N-4080-027 Suppl A&B Rev 0: MSLB Containment P/T

Southern California Edison Company INTERIM CALCULATION CHANGE NOTICE (ICCN)/ CALCULATION CHANGE NOTICE (CCN) COVER PAGE	CALC. NO. N-4080-027	ICCN NO / PRELIM. CCN NO.	N-2	PAGE 1	TOTAL NO. OF PAGES 52
	BASE CALC. REV. 0	UNIT 2 & 3	CCN CONVERSION: CCN NO. CCN- 2	CALC. REV. 0	
	CALCULATION SUBJECT: CONTAINMENT P/T ANALYSIS FOR DESIGN BASIS MSLB - SUPPLEMENT B				
CALCULATION CROSS-INDEX <input checked="" type="checkbox"/> New/Updated index included <input type="checkbox"/> Existing index is complete	ENGINEERING SYSTEM NUMBER / PRIMARY STATION SYSTEM DESIGNATOR 1301 / ABB			Q-CLASS II	
	CONTROLLED PROGRAM OR DATABASE ACCORDING TO SO123-XXIV-5.1	PROGRAM / DATABASE NAME (S) <input checked="" type="checkbox"/> ALSO, LISTED BELOW	VERSION/RELEASE NO.(S)		
1. BRIEF DESCRIPTION OF ICCN / CCN:	<input checked="" type="checkbox"/> PROGRAM <input type="checkbox"/> DATA BASE	NE100 (COPATTA)	G1-15

Add Supplement B to the base calculation.

Calc No. <u>N-4080-027</u>	DCP/FIDCN/ FCN No. & Rev. <u>N/A</u>	CCN CONVERSION: CCN NO. CCN- <u>2</u>
Subject: <u>CONTAINMENT P/T ANALYSIS FOR DESIGN BASIS MSLB - SUPPLEMENT B</u> Sheet <u>B1</u> of <u> </u>		
Sy

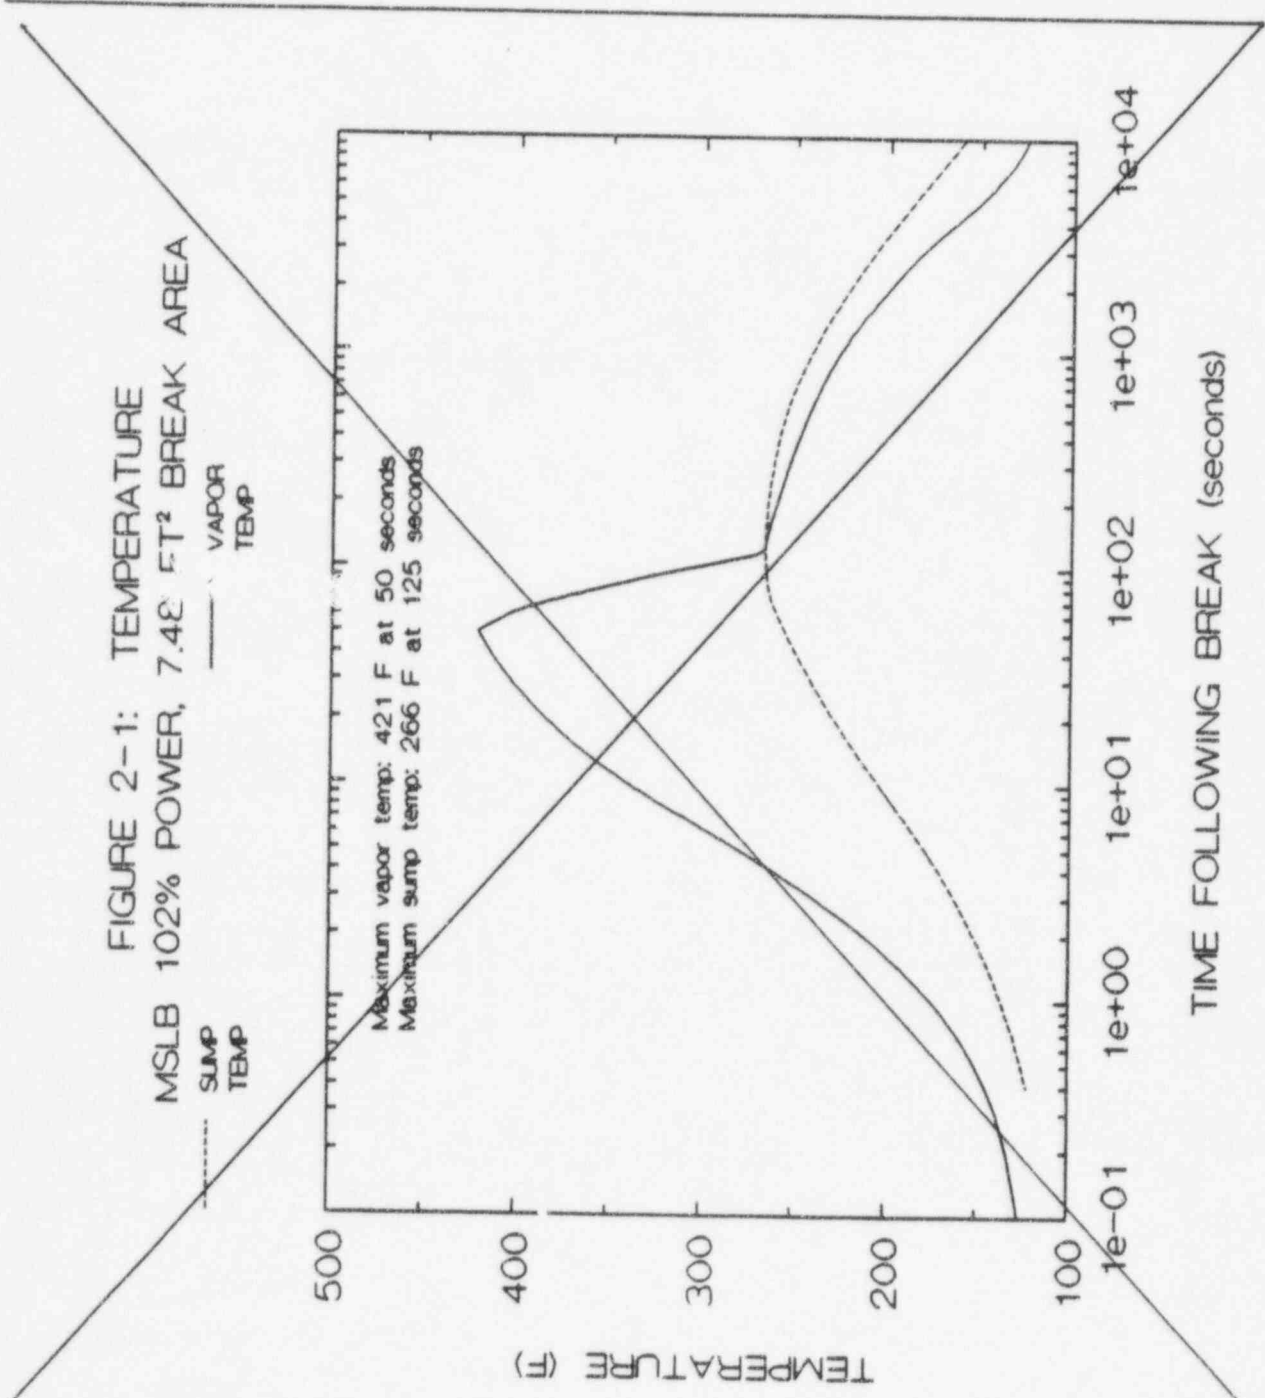
THIS FIGURE IS REPLACED BY FIGURE 2-2 IN SUPPLEMENT B

FIGURE 2-2: CONTAINMENT PRESSURE
MSLB 102% POWER, 7.48 FT² BREAK AREA

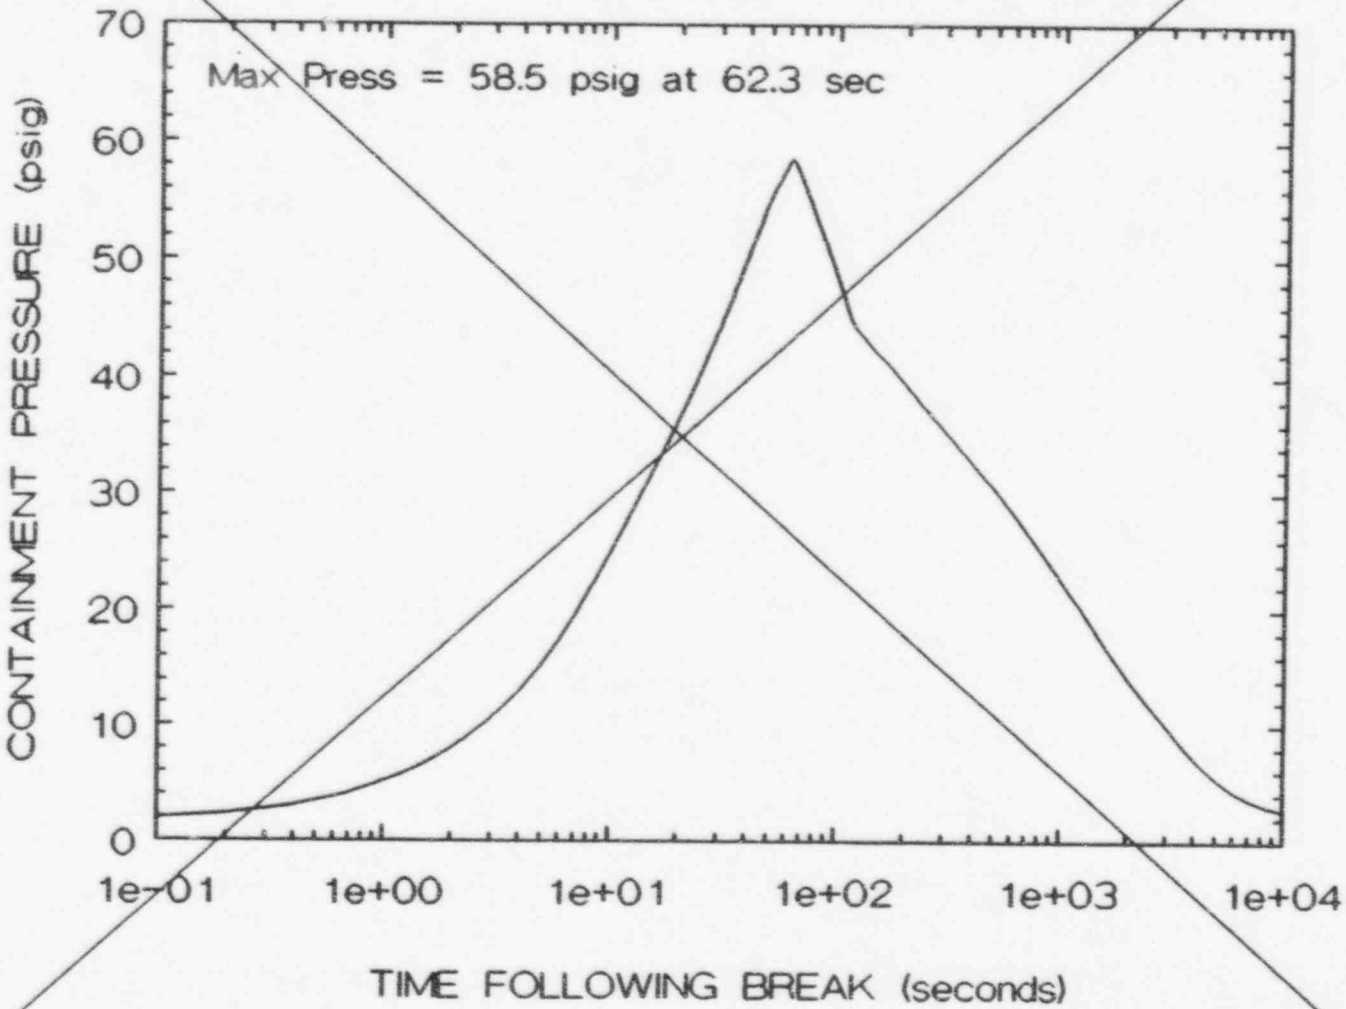
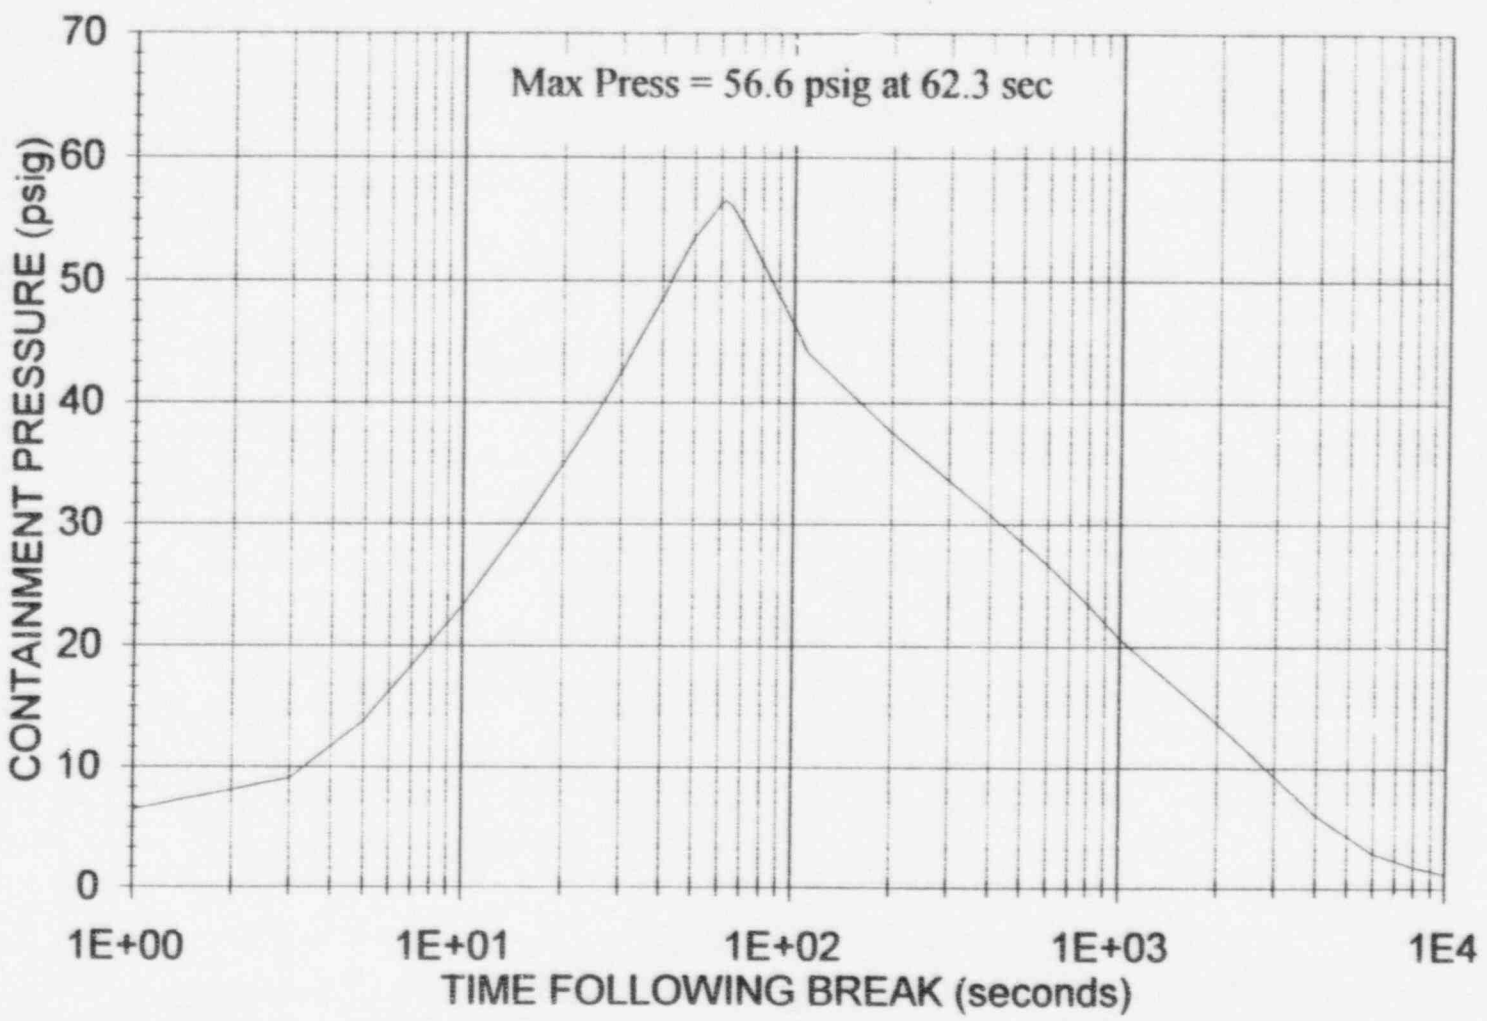
THIS FIGURE IS REPLACED BY FIGURE 2-1 IN SUPPLEMENT B

Figure 2-1 presents the containment gauge pressure versus time for the CONTAINMENT P/T DESIGN BASIS MSLB. The plot in Figure 2.1 is generated using the data presented in Section 10.1.

The calculated peak pressure of 56.6 psig is less than the 60 psig design pressure and also less than the previously identified peak pressure (58.5 psig) in the prior AOR (N-4080-027, reference 6.1). The decrease in the peak pressure is attributed to the change in the initial containment pressure from 1.5 psig to 0 psig.

FIGURE 2-3: CONDENSING HTC
MSLB 102% POWER, 7.48 FT² BREAK AREA

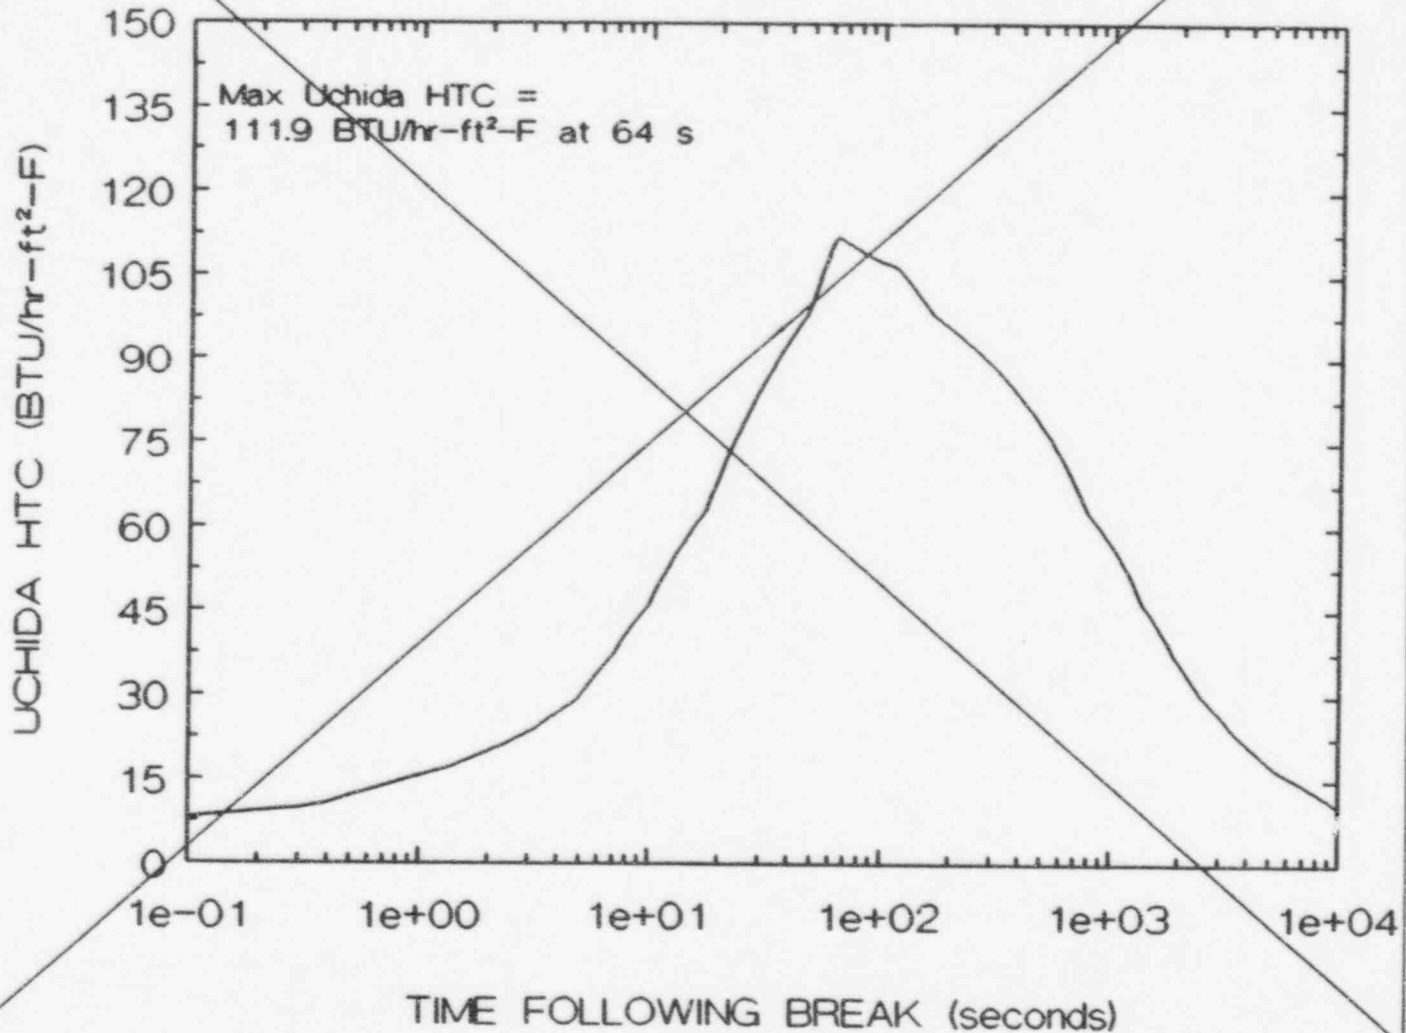
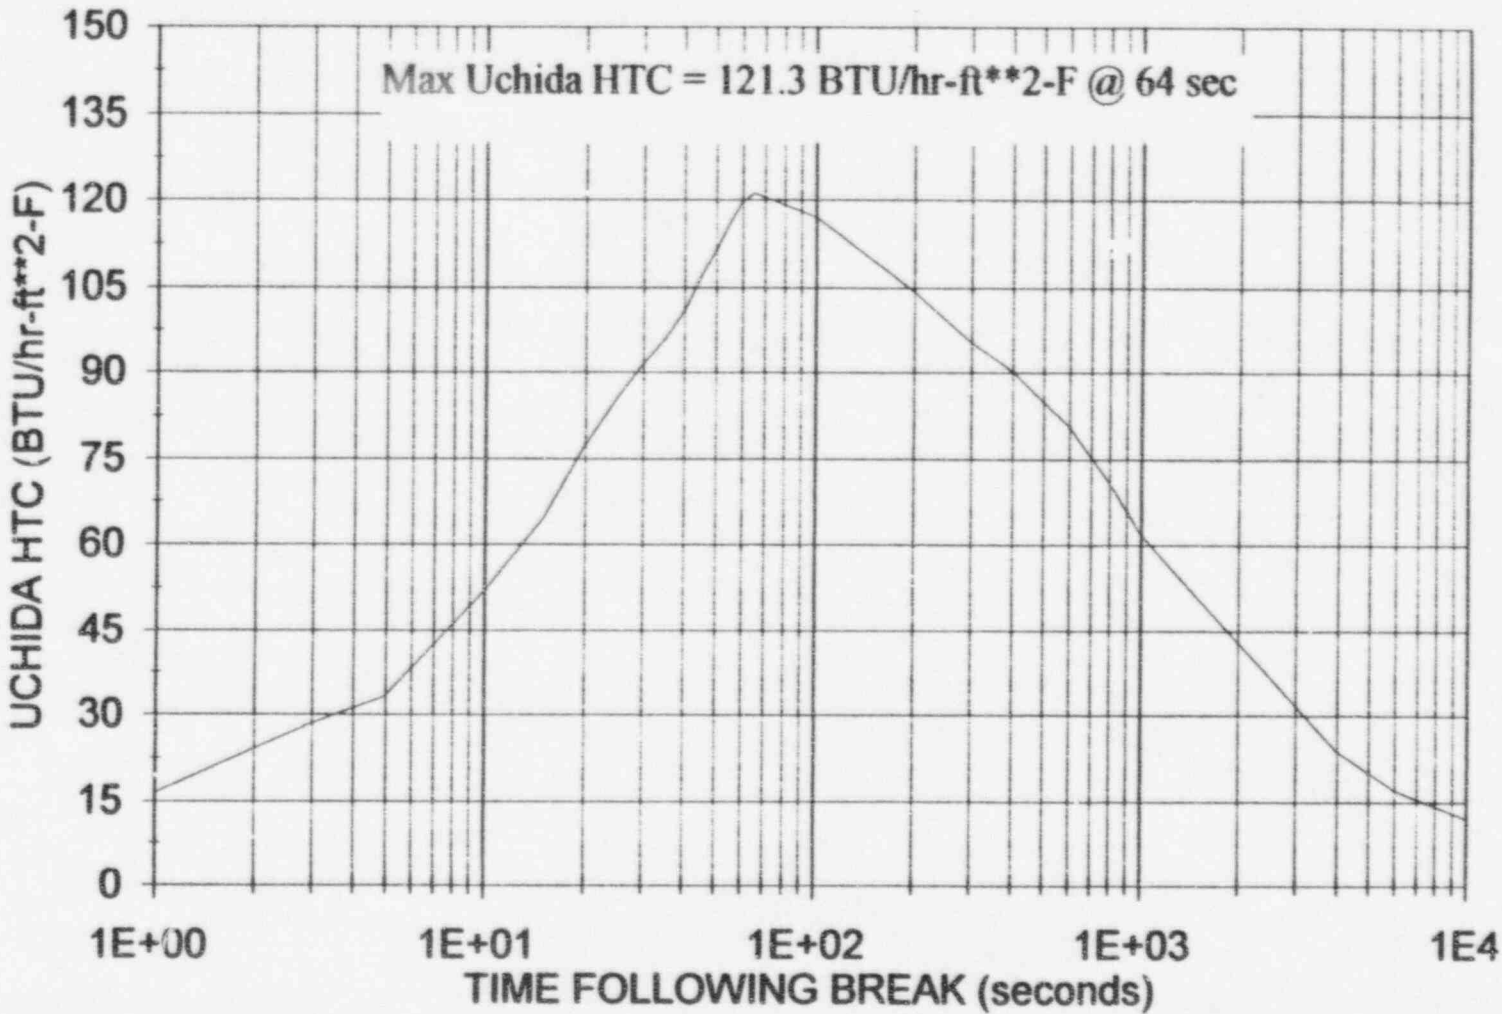
THIS FIGURE IS REPLACED BY FIGURE 2-3 IN SUPPLEMENT B

Figure 2-3 presents the condensing heat transfer coefficient v.s. time used by the COPATTA Code during the DBMSLB. The plot in Figure 2.3 is generated using the data presented in Section 10.1.

FIGURE 2-4: LINER PLATE SURFACE TEMP.
MSLB 102% POWER, 7.48 FT² BREAK AREA

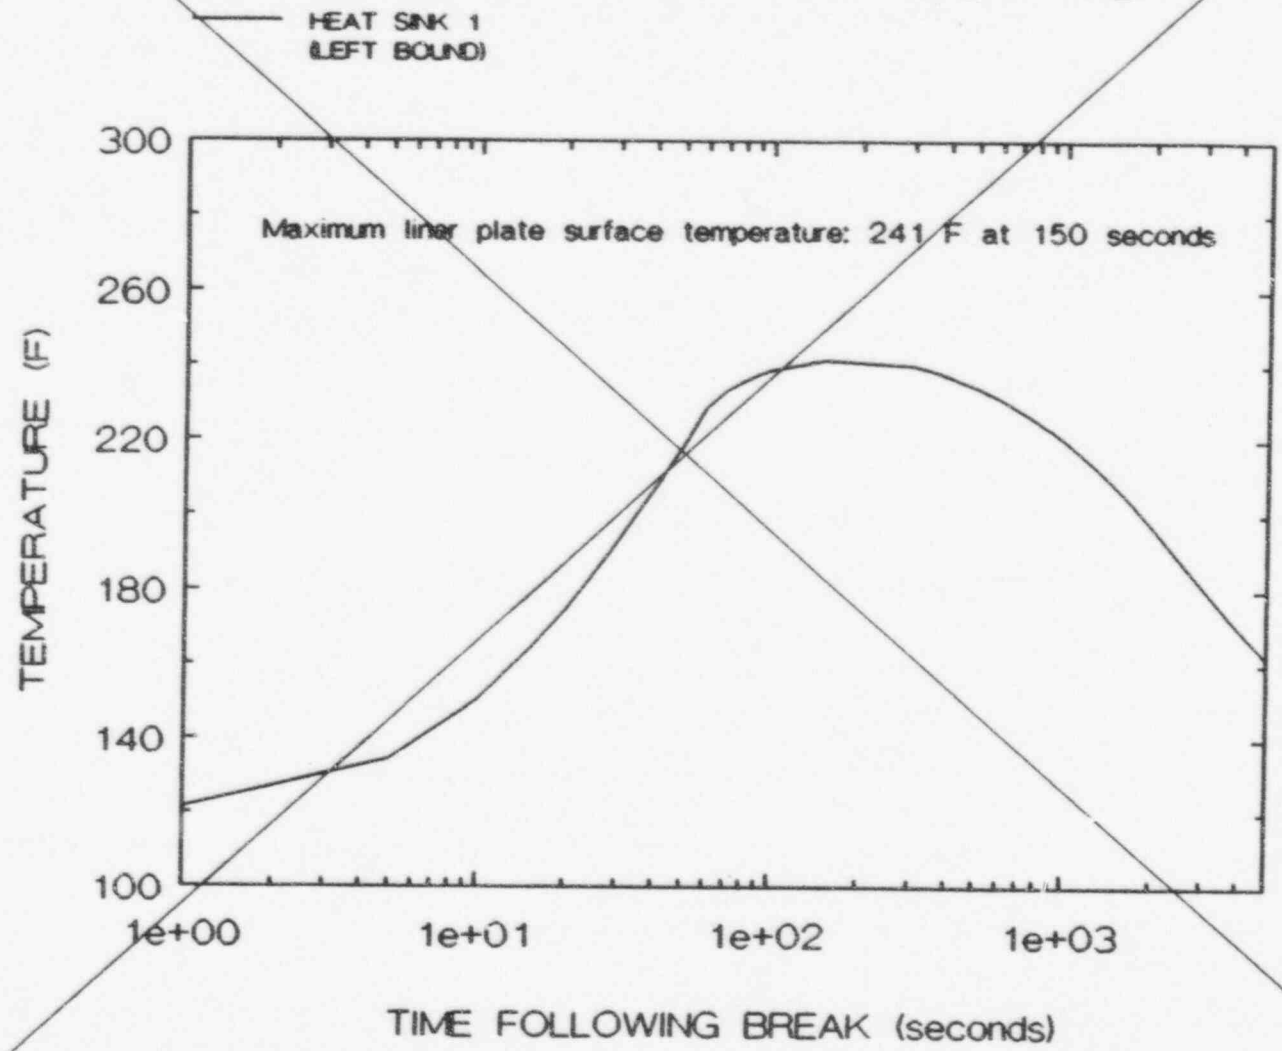
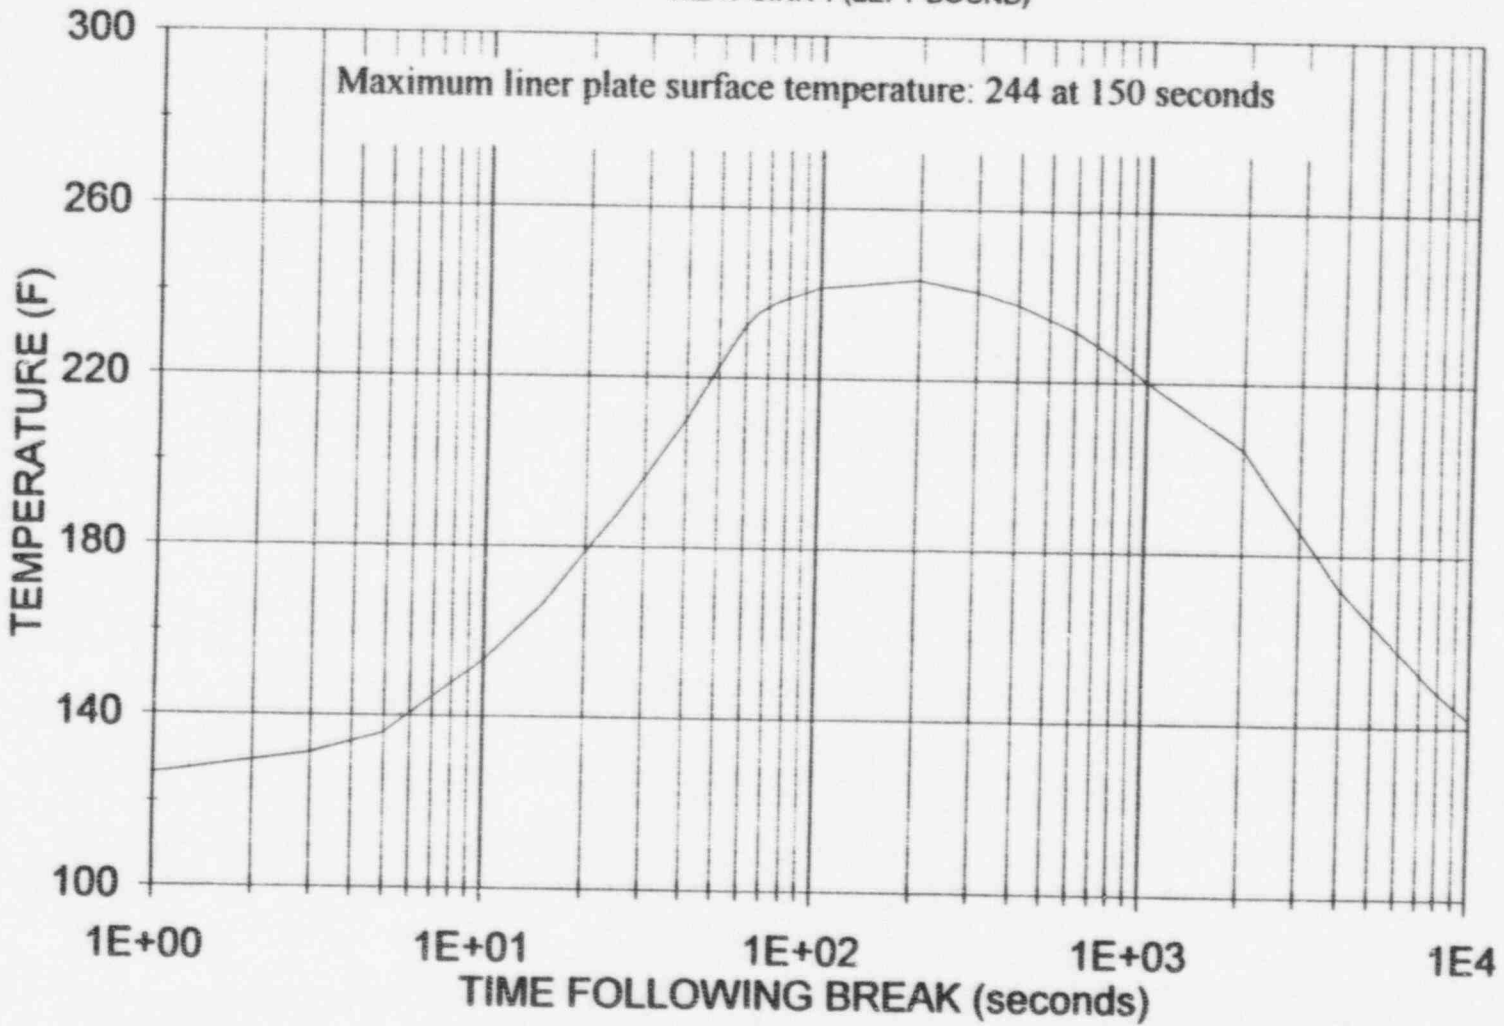
THIS FIGURE IS REPLACED BY FIGURE 2-Y IN SUPPLEMENT B

Figure 2-4 presents the inside surface temperature of heat sink 1 (reactor building dome, painted steel liner plate) to represent the maximum post-MSLB temperature of the containment structure. The plot in Figure 2.4 is generated using the data presented in Section 10.1.

The calculated peak vapor temperature of 427.7°F is greater than the 300°F design temperature, however the duration of the event is sufficiently brief to prevent heating of the containment structural materials beyond the design limits. The thermal response of the 0.25" thick containment steel liner plate to the MSLB environment shown in figure 2-4 presents a conservative example of the transient heating of the containment structure during the accident. As shown in the figure, the liner plate remains below 250 °F during the MSLB event.
